This document summarizes the changes between the previous SAP5 silicon revision C and the current silicon revision D. These include requested UART design changes. The purpose of the redesign was to correct reported timing errors by the UART in the following modes: Master, Monitor, and Repeater. A problem with slave communication in special network constellations was also fixed.

2 Indication of the *End_Bit* Transmission Error

Figure 2.1 Comparison of Valid MAN-Code Signal to Faulty MAN-Code Signal

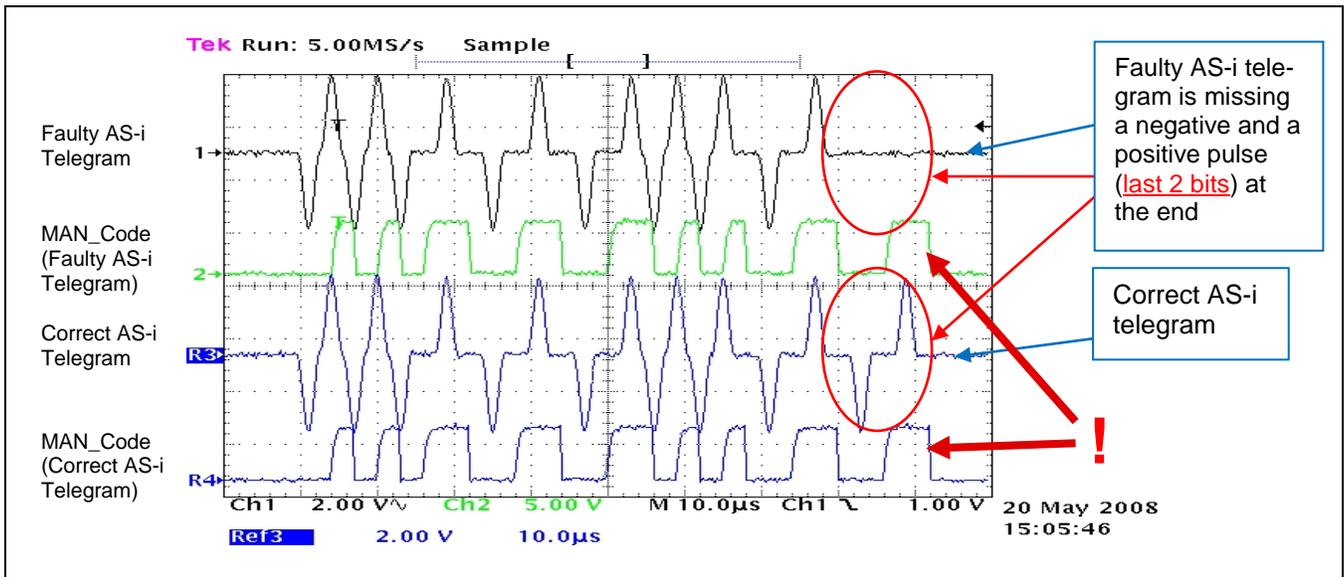
If the SAP5 revision C operates in Master Mode or in Repeater Mode, the error signaling for an *End_Bit_Error* does not work correctly. In some special cases, the generated MAN-Code of a signal with an *End_Bit_Error* looks similar to the MAN-Code of a signal without any errors as demonstrated in Figure 2.1.

This malfunction of the SAP5 revision C results in an MAN coded output signal that does not allow distinction between correct AS-I pulse sequences and pulse sequences that are shortened (missing one negative and one positive pulse). It occurs only under the following conditions:

- The parity of the signal is even.
- The last bit of the corrupt telegram is equal to binary 1.
- The *Stop_Bit* and the *Parity_Bit* or the *Start_Bit* and the *Control_Bit* are missing.
- If the *Start_Bit* and the *Control_Bit* are missing, the first pulse must have a negative polarity.

1. A new principle for ASI-telegram pause detection was implemented. The previous method caused erroneous pause detection in some cases; e.g., a telegram starting with a wrong Start bit (SB=1) and second bit = 0.
2. A new *Endbit_error* detection principle was implemented to comply with the *AS-I Complete Specification V3.0*. The new principle ensures that an *Endbit_error* is detected only if the polarity of the pulse at time (36µs/78µs ± tolerance) is negative.
3. The internal computation of *No_info_error*, *Timing_error*, and *Length_error* was reviewed and corrected to comply with the *AS-I Complete Specification V3.0*.

Figure 3.1 Test for SAP5 Revision C Error in Master Pause Detection

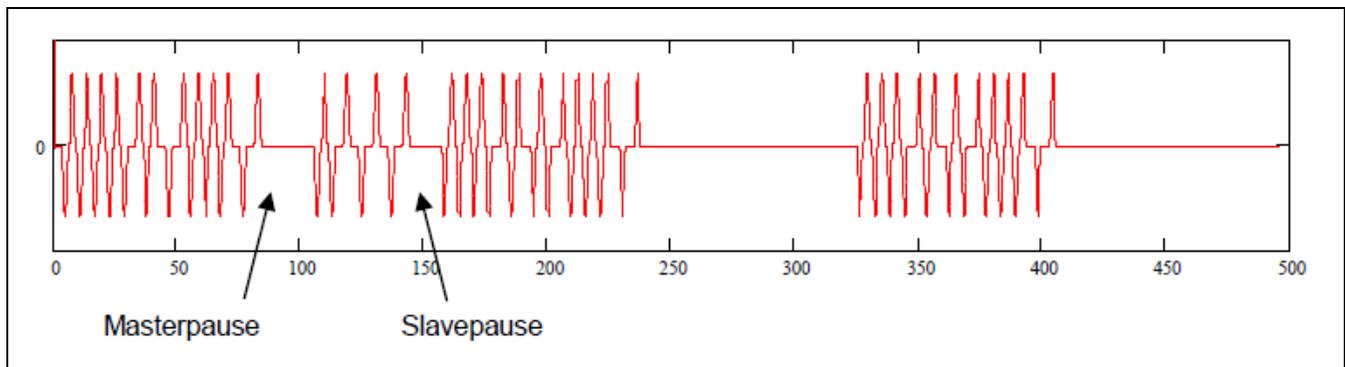
If the previous SAP5 revision C is operated in Slave Mode, the UART Master Pause detection does not always function correctly when the UART must listen to slave responses from a different slave. Depending on the actual AS-I line pulse timing, a slave response from a different slave is sometimes not recognized correctly, which results in a UART communication error. This prevents the Slave from understanding the next Master telegram correctly. If the Master telegram addresses the Slave itself, the error leads to a missing slave response and the Slave replies on a second repetition of the Master Call to its own address in asynchronous mode.

Figure 3.1 shows a telegram test case to reproduce the error. The AS-I signals shown in Figure 3.1 were generated by a signal generator that allowed sweeping the Master Pause and Slave Pause duration over the allowed specification limit. The first Master Call contains a different slave address than the tested slave. The second and third master calls address the tested slave. The tested slave replied with the erroneous behavior for certain Master pause and Slave pause scenarios only. The majority of the test cases were passed without error.

A new principle of AS-i telegram pause detection was implemented in SAP5 silicon revision D that is more precise and able to cover all valid timing scenarios for Master and Slave pauses. The new principle is now independent of the internal timing constraints of the UART state machine.
